ADDENDUM NO. 2
Penguin Life Support System Upgrade
REQUEST FOR BIDS #11-1717
August 26, 2010

THE FOLLOWING ARE CHANGES TO THE CONTRACT DOCUMENTS

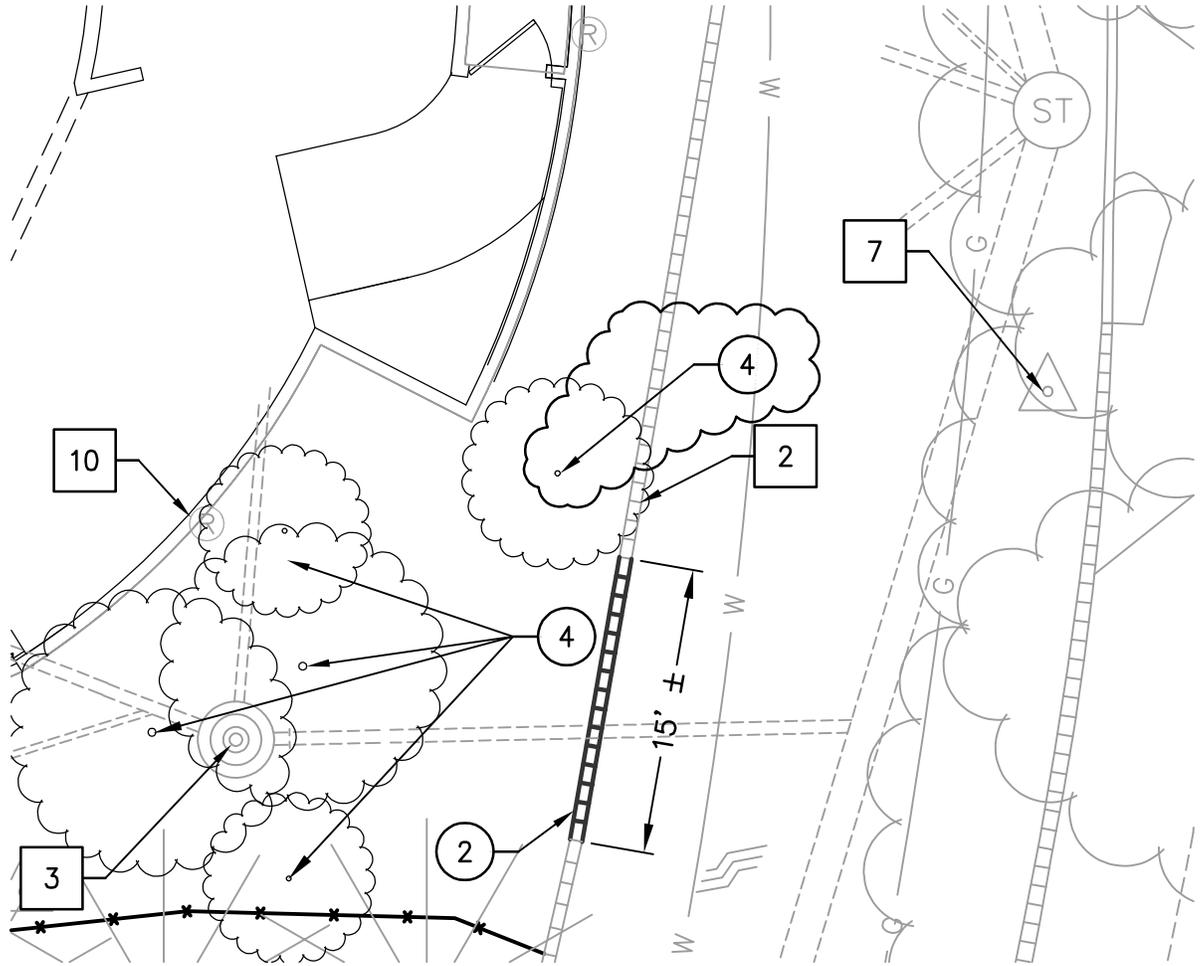
19. According to structural drawing S2.2 the trickling filter weighs 25,000 lbs. However, what does the height of the vessel need to be to ensure the gravity components of the design will work?

Answer: Structural design based on a higher water depth than anticipated operating depth of about 3'. Total height of vessel approximately 9' (3.5' open at bottom, 3' of media set on a fiberglass divider and about 2'-2.5' above media for pipe connections).

SHEET NO.:
RC 01

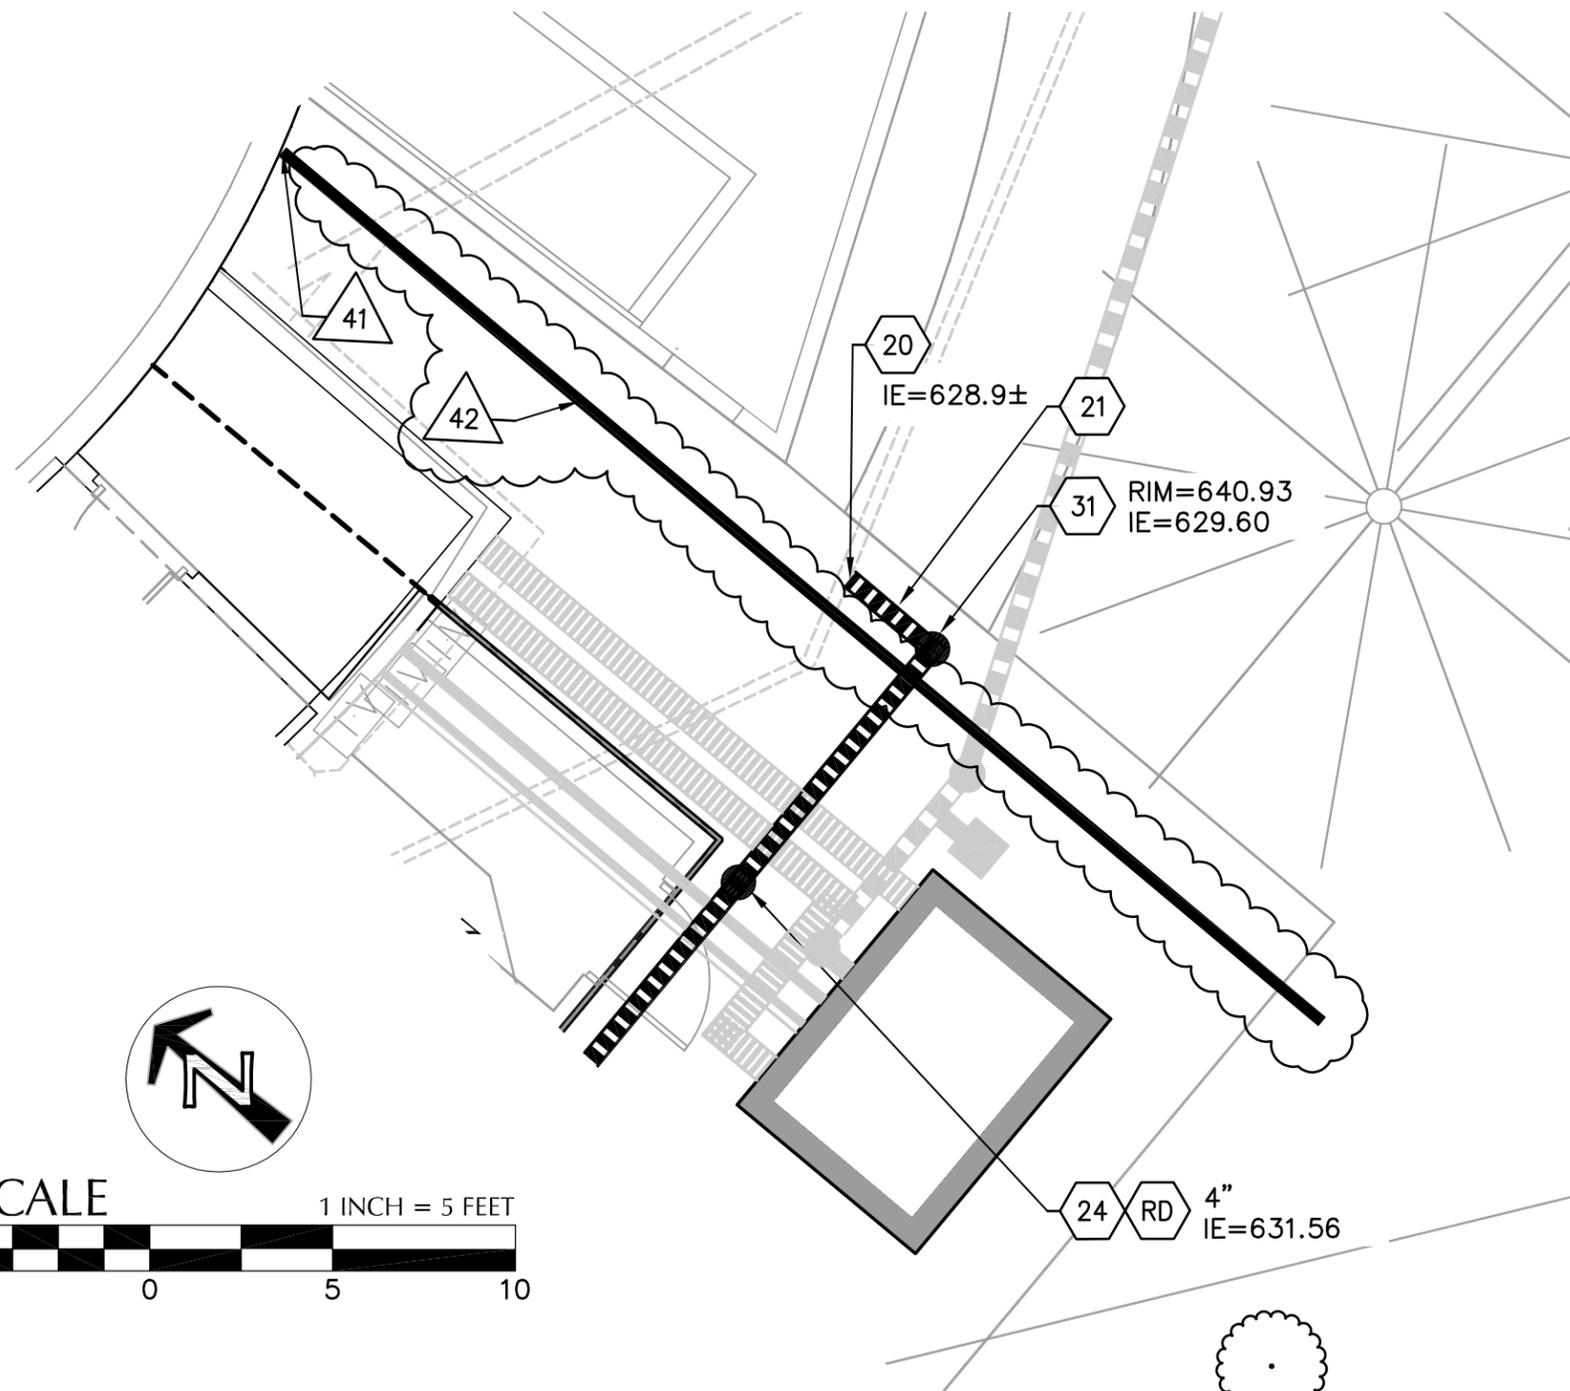
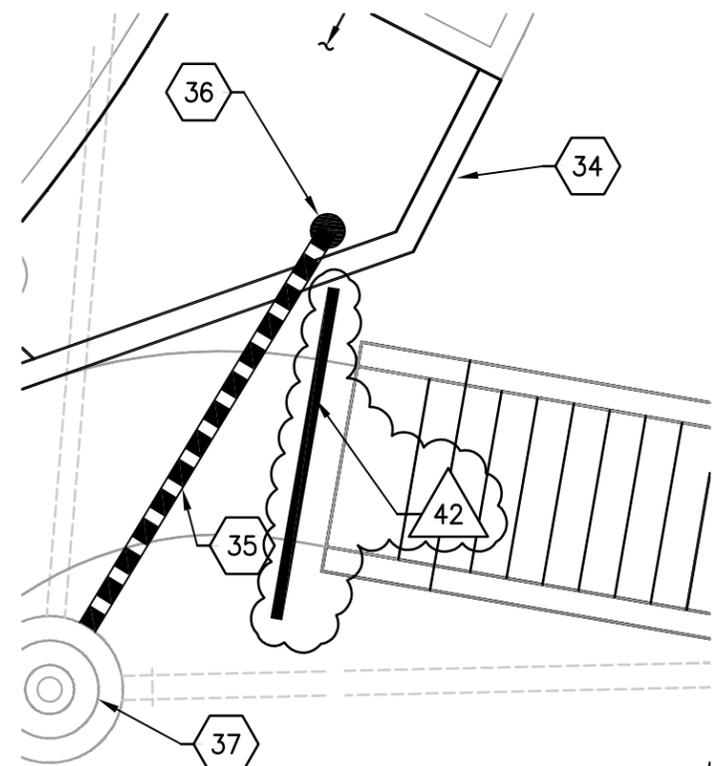
A. DRAWING RC01 NAME: G1.3 SITE DEMOLITION PLAN, REVISION MADE:

- 1. As shown on drawing.

TITLE:
ADDENDUM 3 - ADDITIONAL TREE DEMOLITION

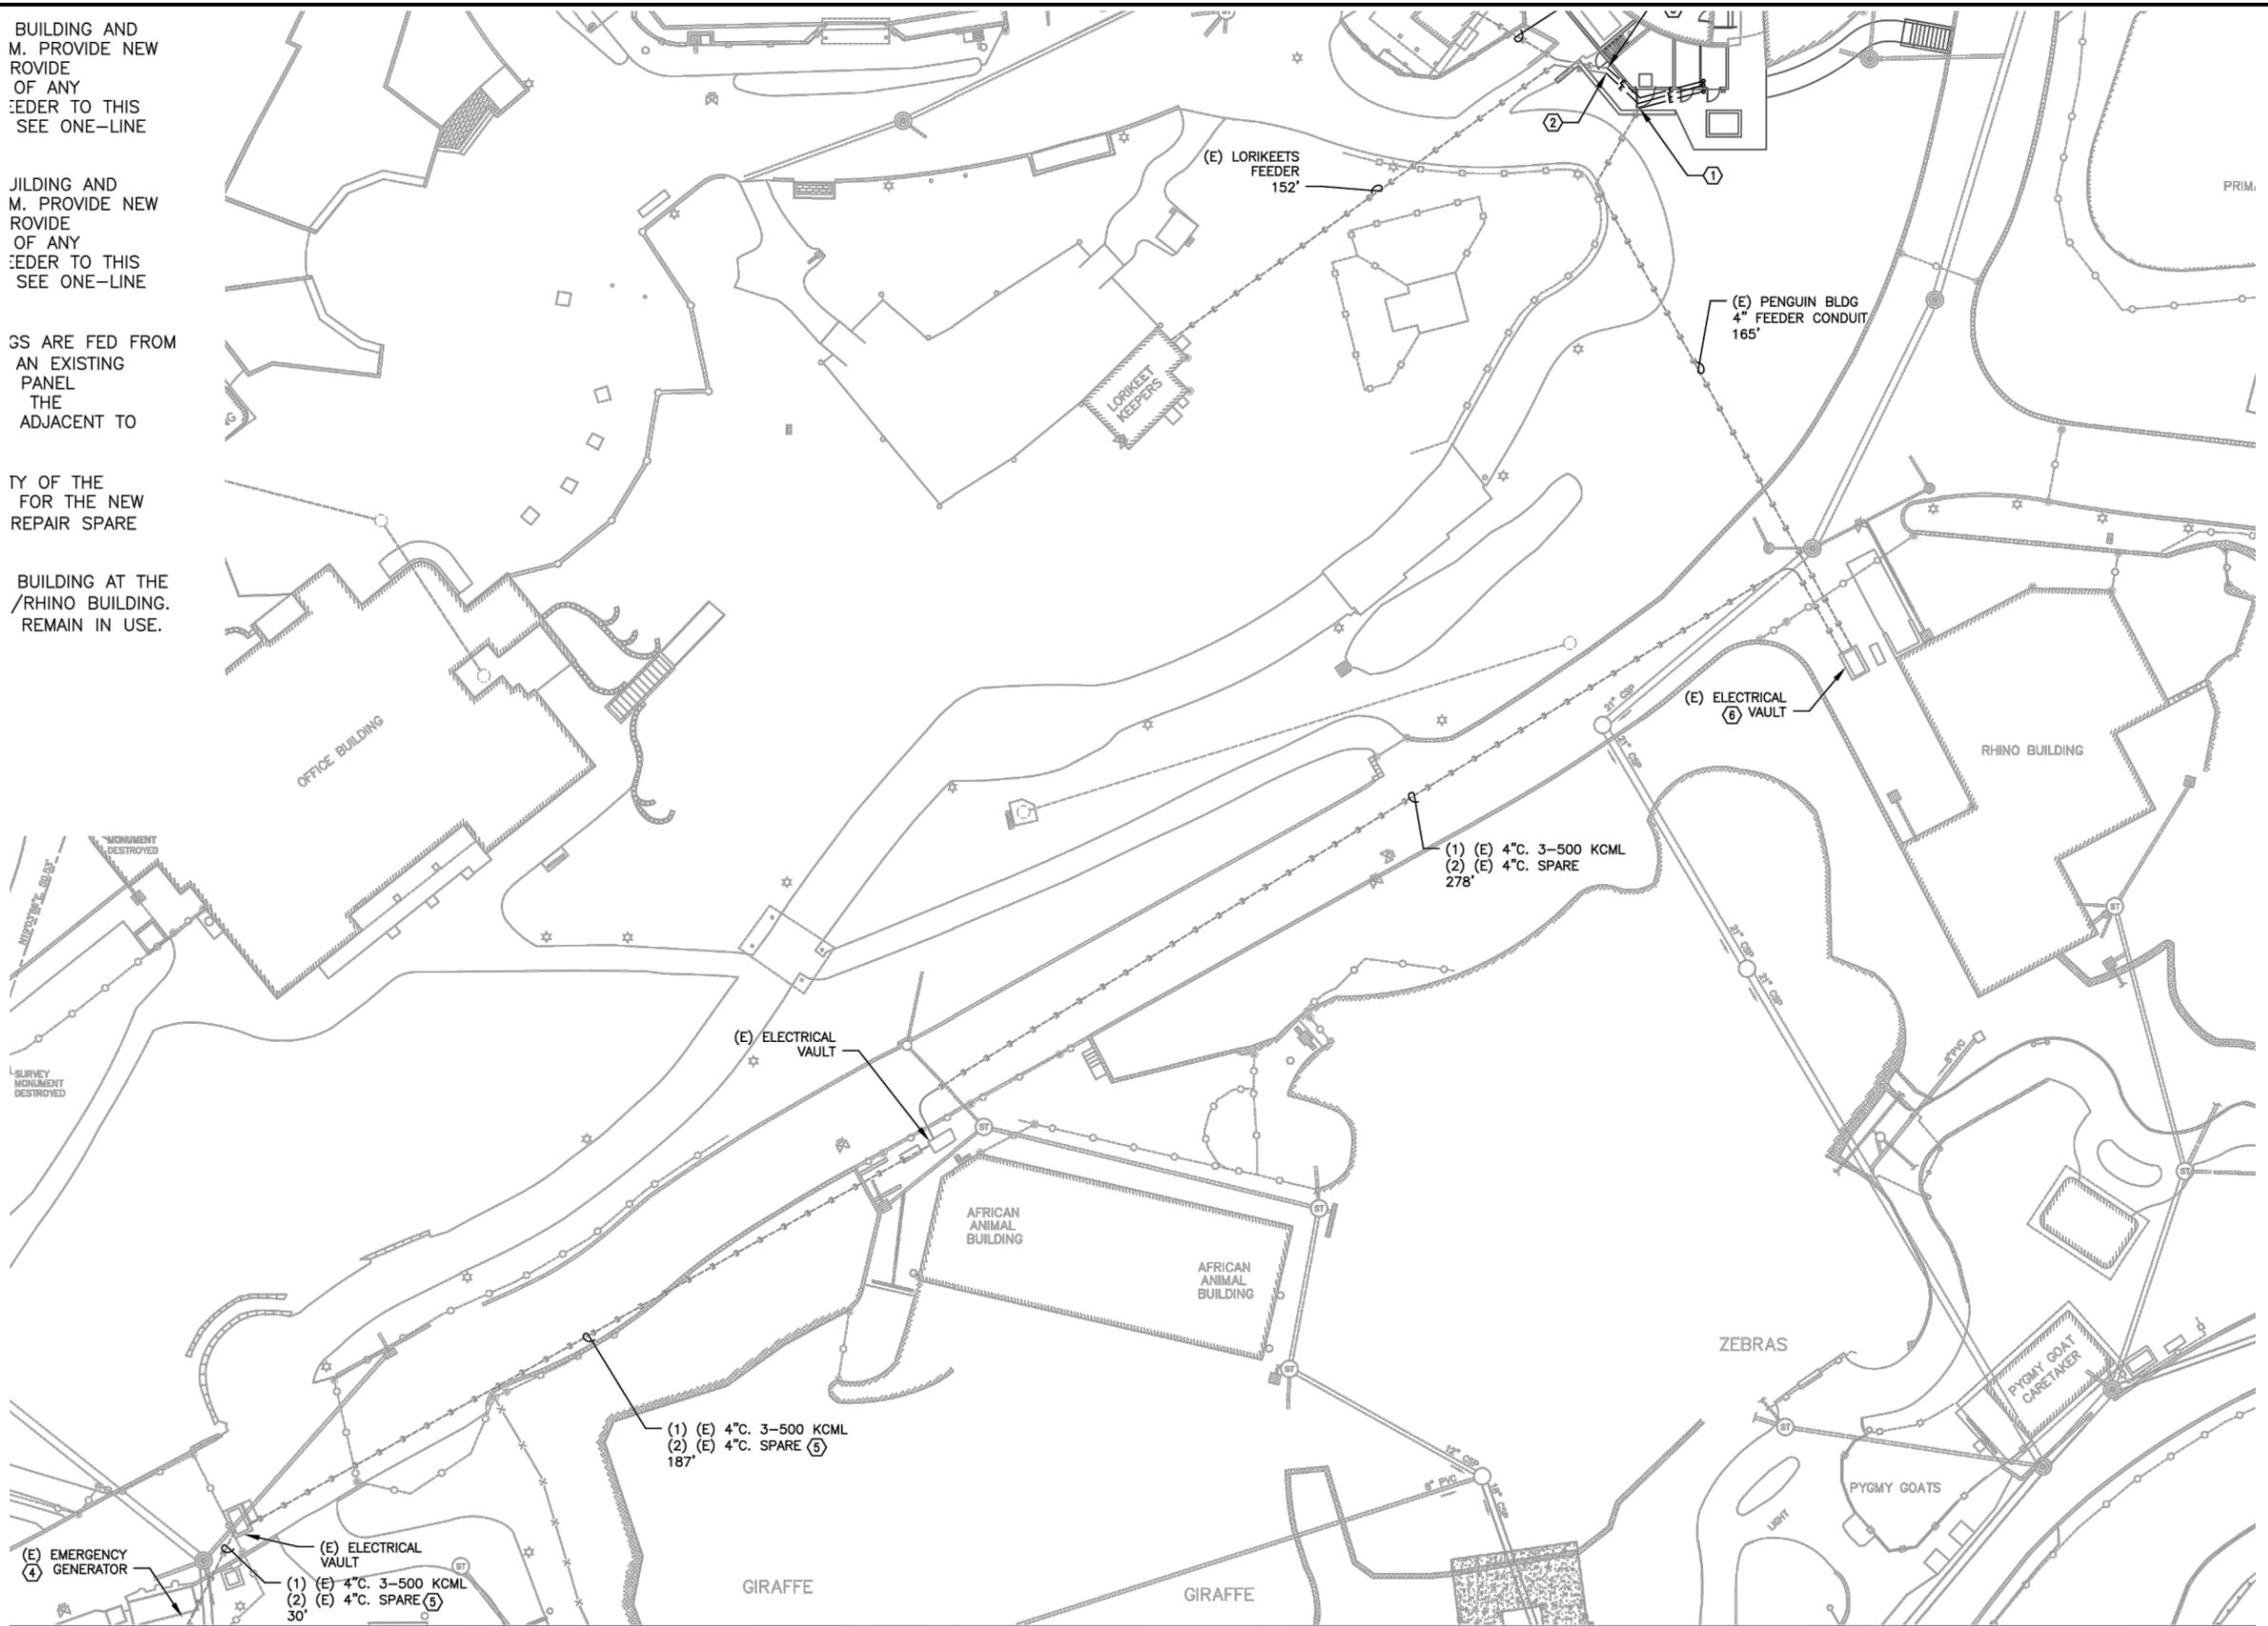
B. DRAWING RC02 NAME: C3.0 UTILITY PLAN, REVISION MADE:

- 1. As shown on drawing.

- 40 INSTALL (1)-4" AND (1)-2" SCH. 40 PVC SLEEVES 30" DEEP EXTENDING 1' BEYOND EDGE OF PAVING; AND MARK FOR FUTURE IRRIGATION LOCATE.
- 41 PROVIDE SWEEP BEND AND RISER FOR IRRIGATION SLEEVE TO CONTROL PANEL.
- 42 INSTALL (1)-4" SCH. 40 PVC SLEEVE 30" DEEP EXTENDING 1' BEYOND EDGE OF PAVING AND MARK FOR FUTURE IRRIGATION LOCATE.
- 43 COORDINATE SLEEVE LOCATION WITH BASEMENT IRRIGATION SUPPLY.
